G-49

Cleaning Water For
Cleaning and Flushing
Tanks Only Unsafe to
Drink

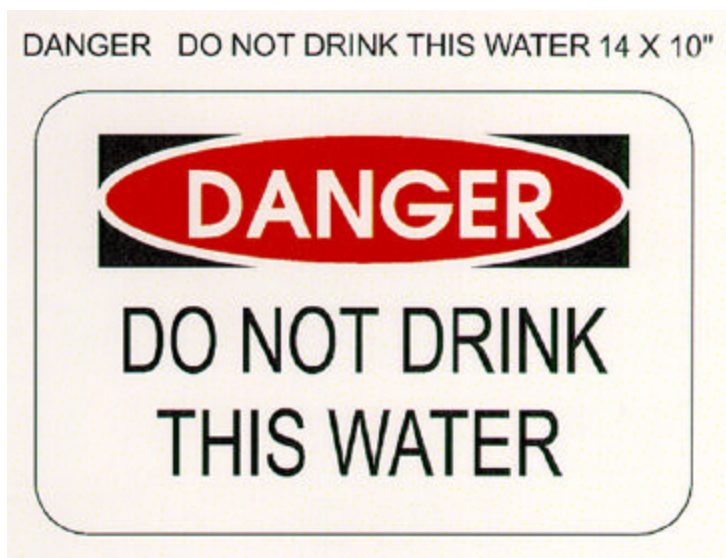
Identifies use for water
source and reduces
chance of unintentional
exposure to health risk.
Notes on left and top of
sign show
proportion/scaling design
information according to
USACE guidelines (see
appendix A).

Another sign should direct
viewer to potable water
supply.
